# MEMORANDUM

Reference: PPSSWC-121 (Council Reference: DA20/0824)  
To: Sydney Western City Planning Panel  
From: Robert Walker, Senior Development Assessment Planner  
Date: 28 March 2022  
Subject: **Proposed Residential Flat Buildings at No. 46 Evan Street, Penrith**

PEDESTRIAN PATHWAY STRUCTURE  
SCALE 1:150

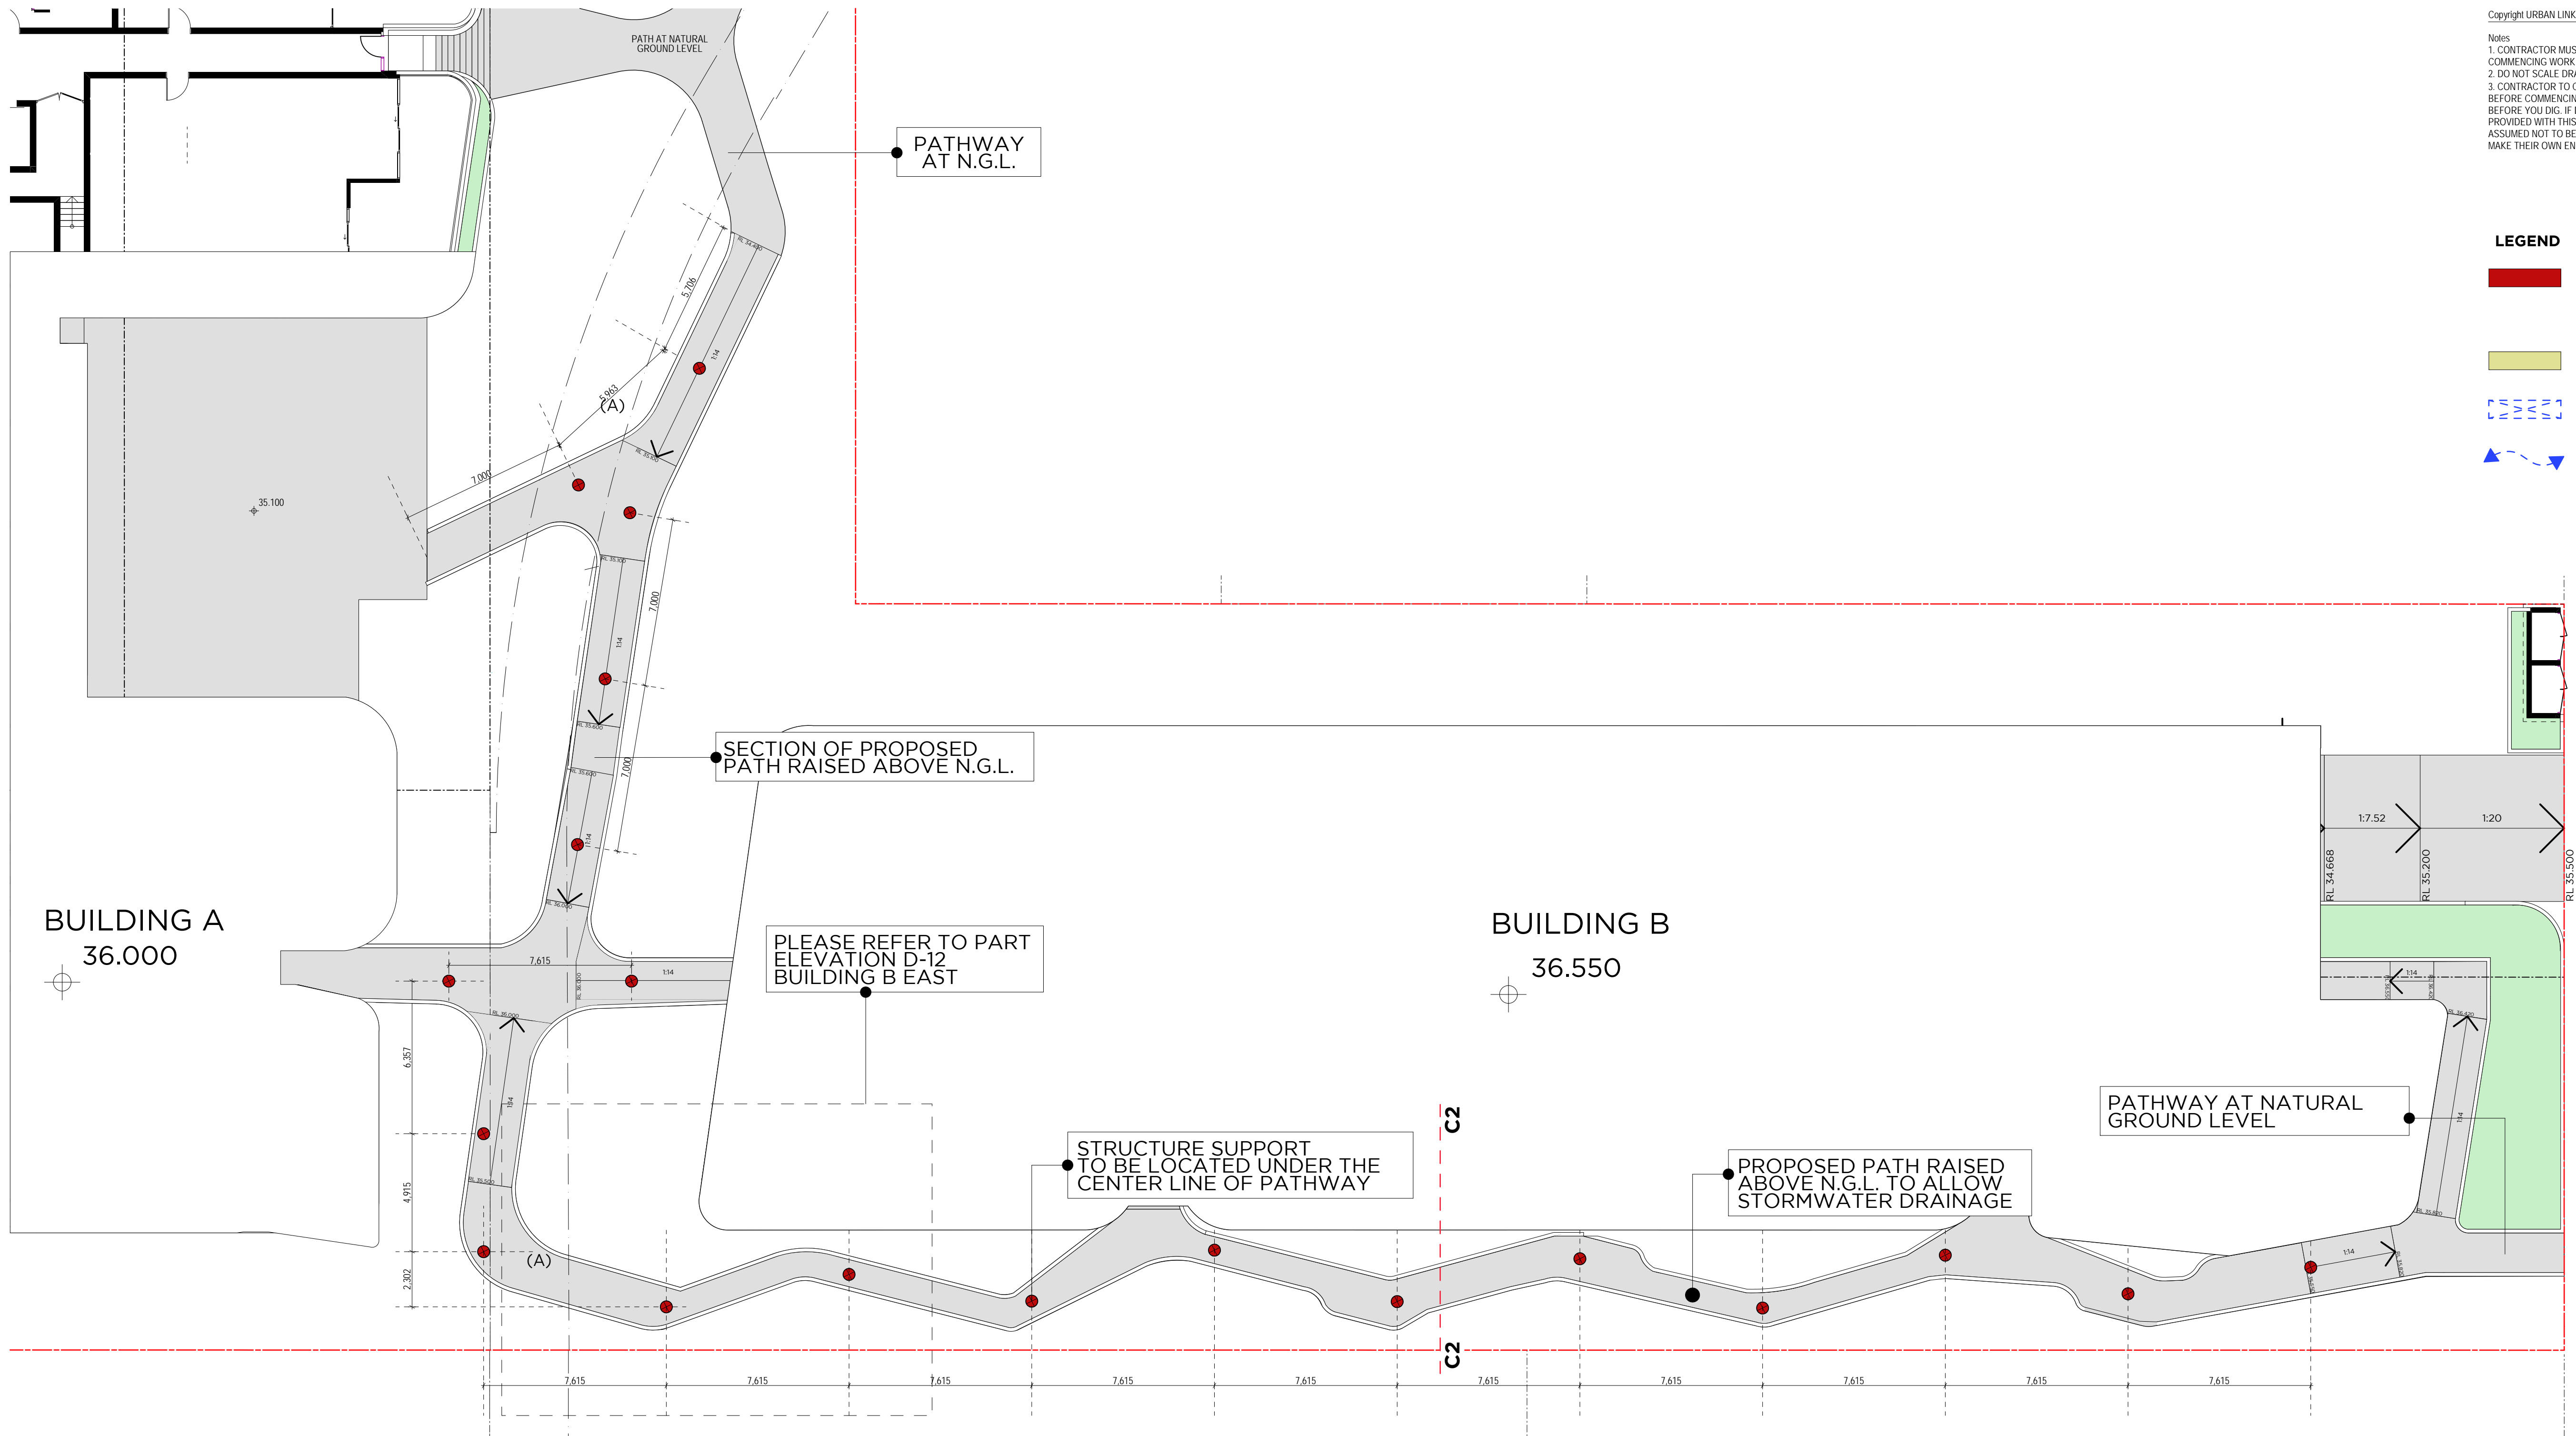
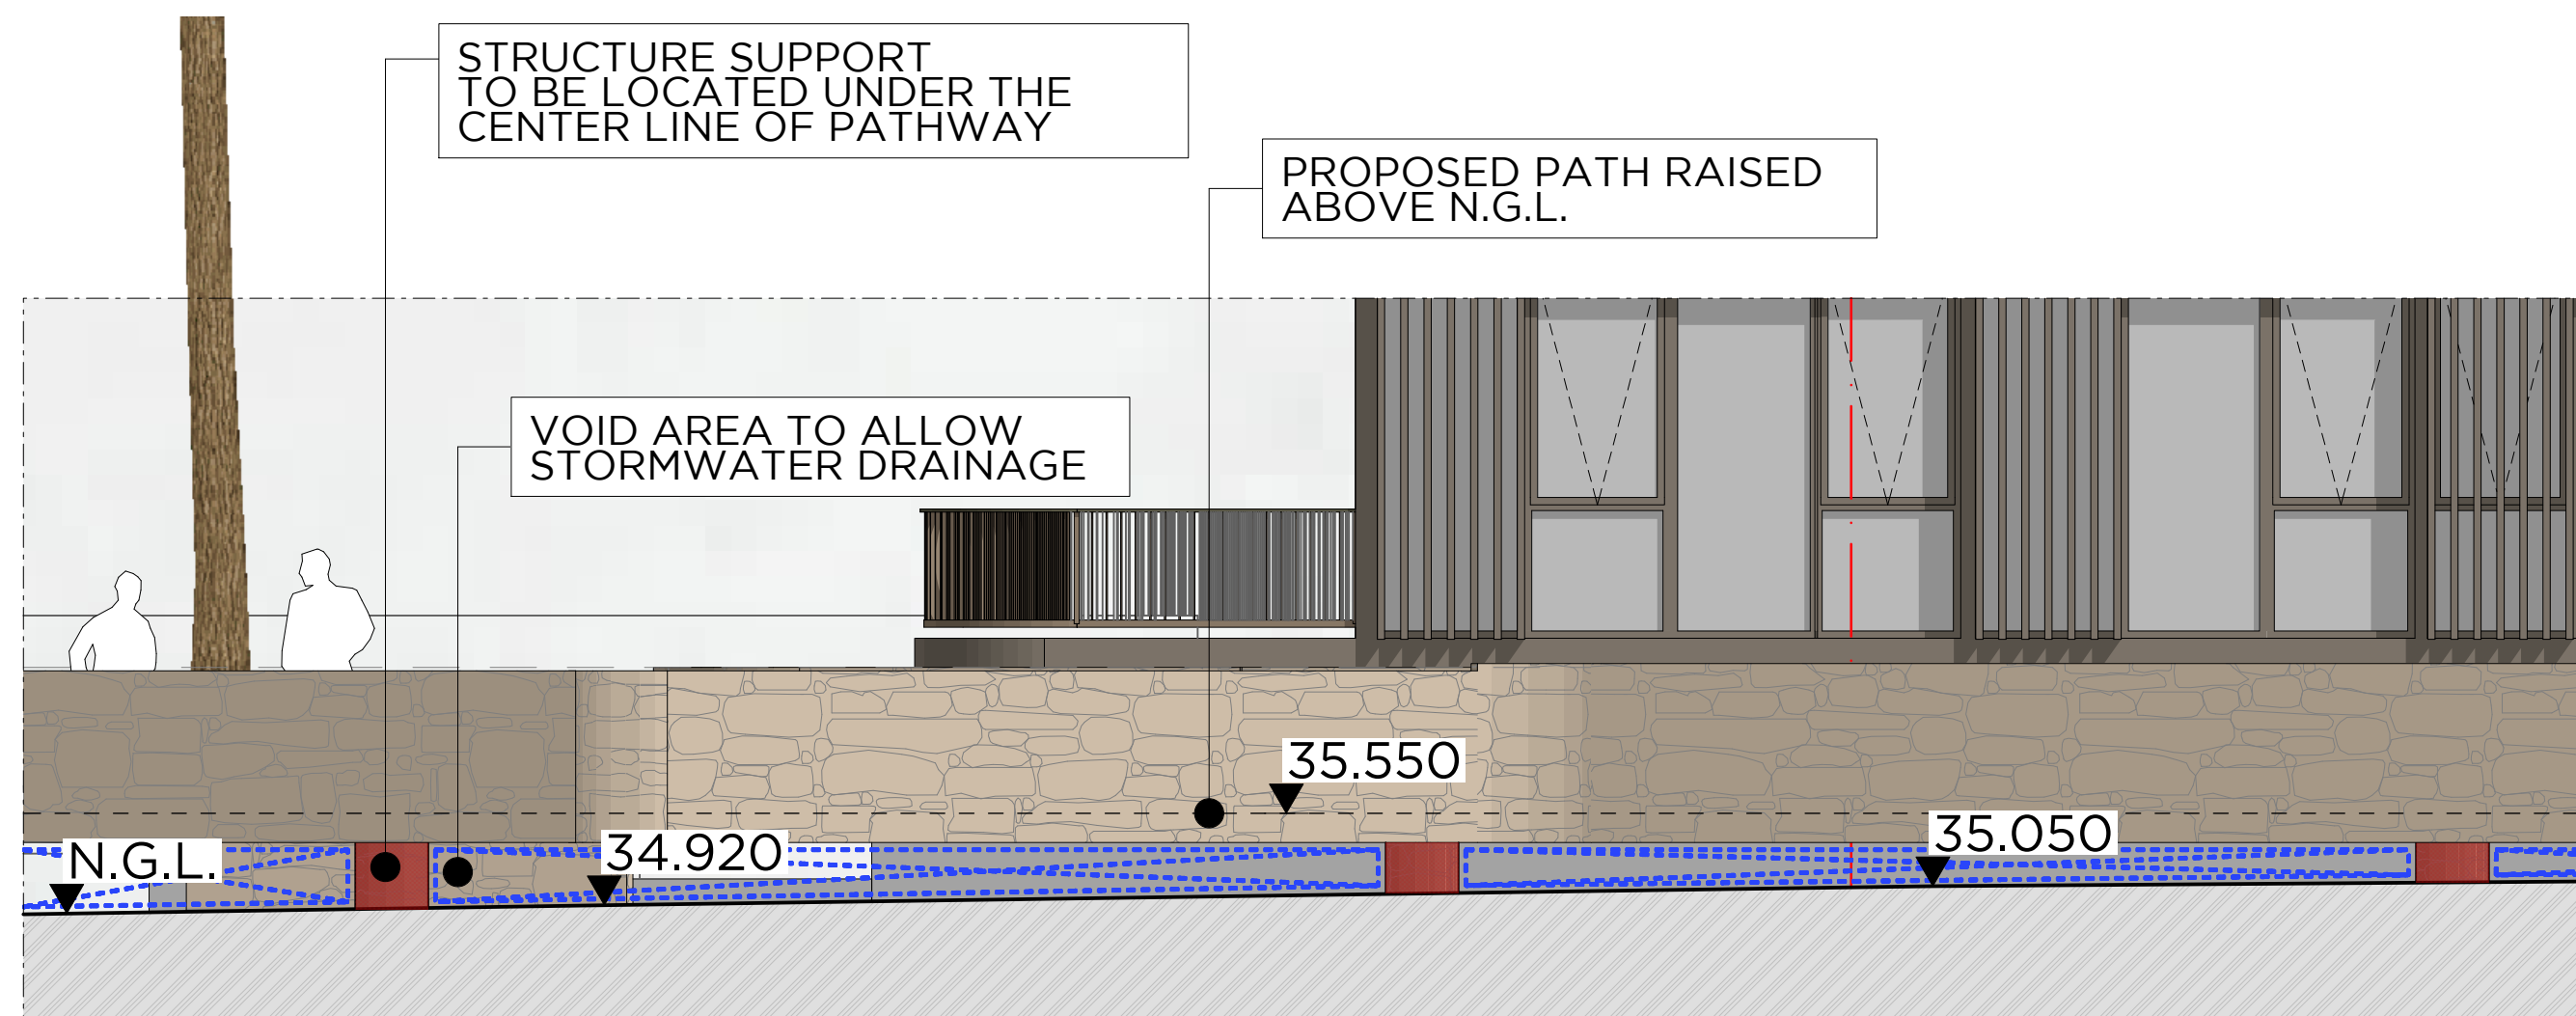
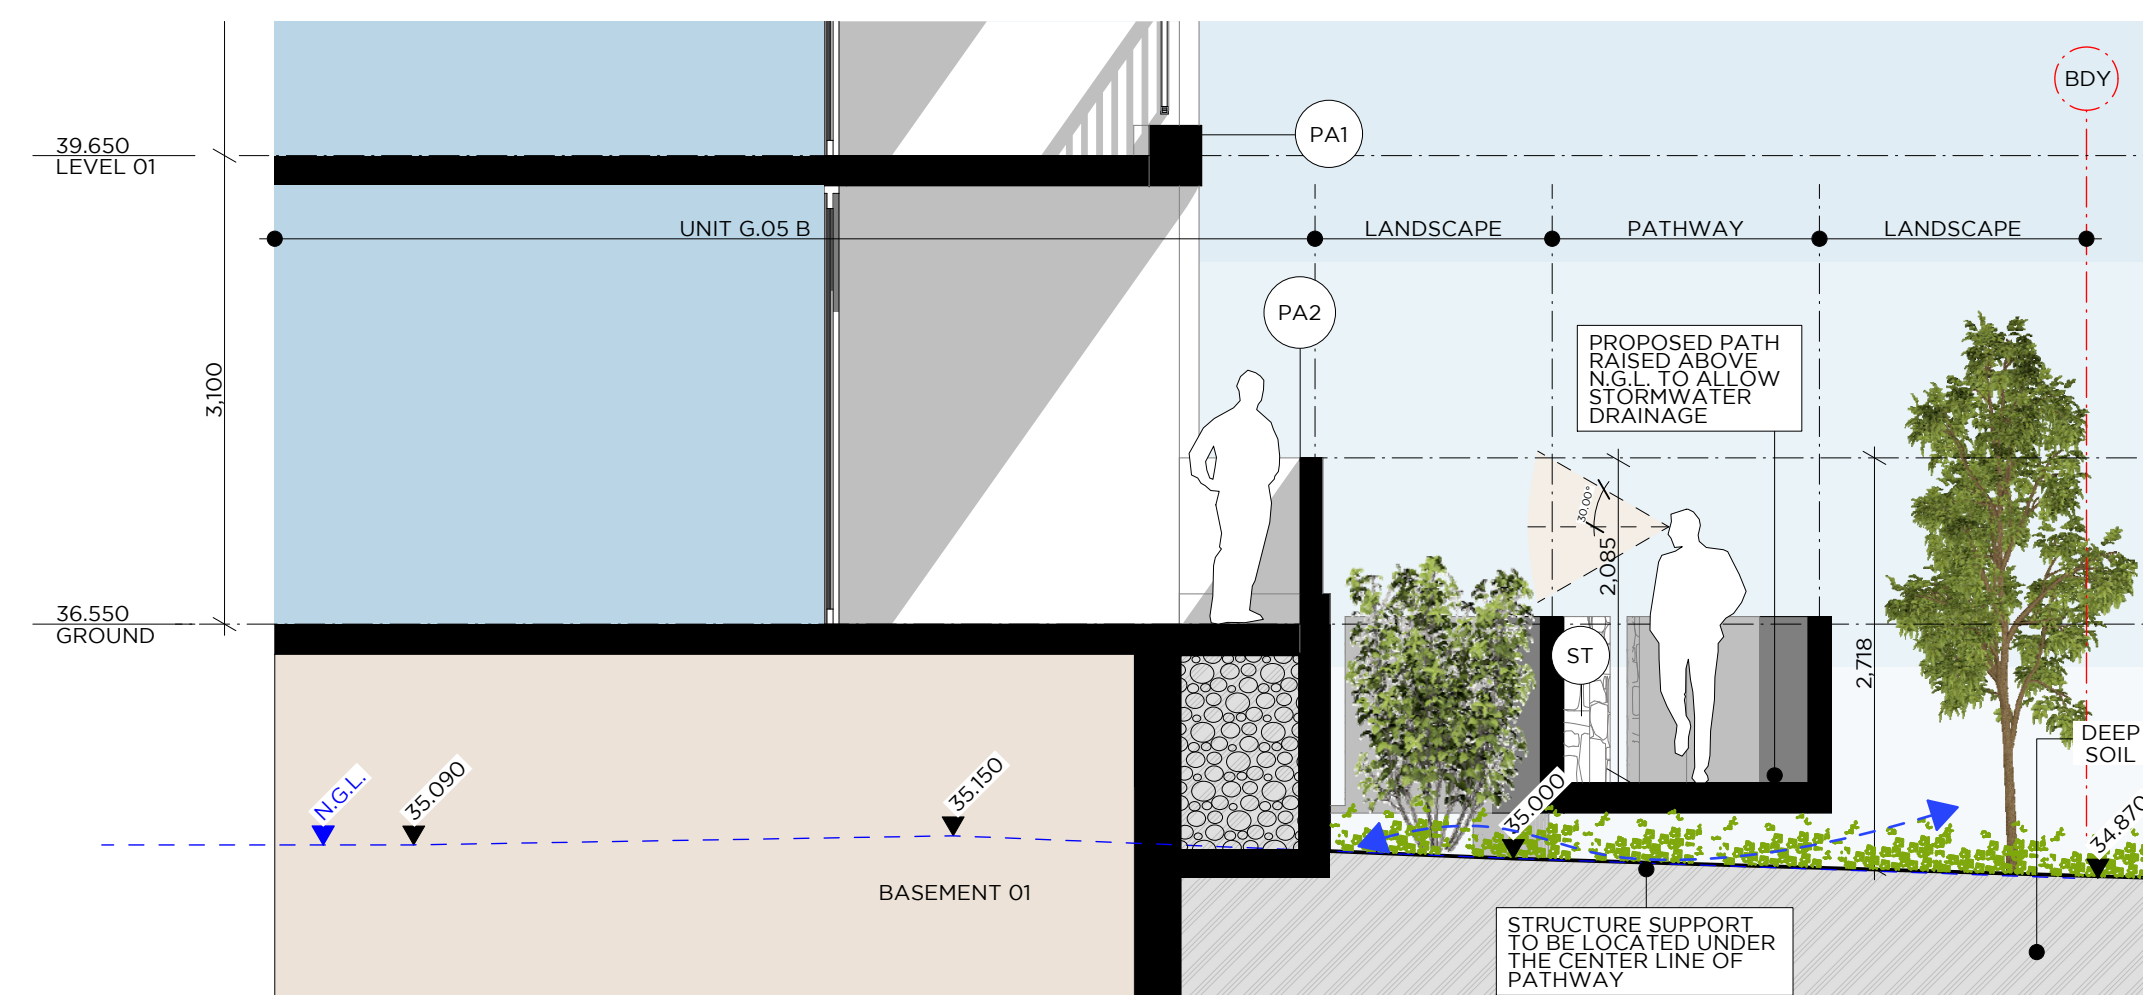
The amended pathway plan still involves the positioning of columns associated with the suspended pathway either within or directly alongside the alignment of the Council's Trunk Drainage System (drainage channel / easement).

This concern related simply to structural elements of the pedestrian pathway that traverses the Council drainage easement.

The amended landscape plan shows the structural elements have now been removed from the easement. This plan accompanies this advice.
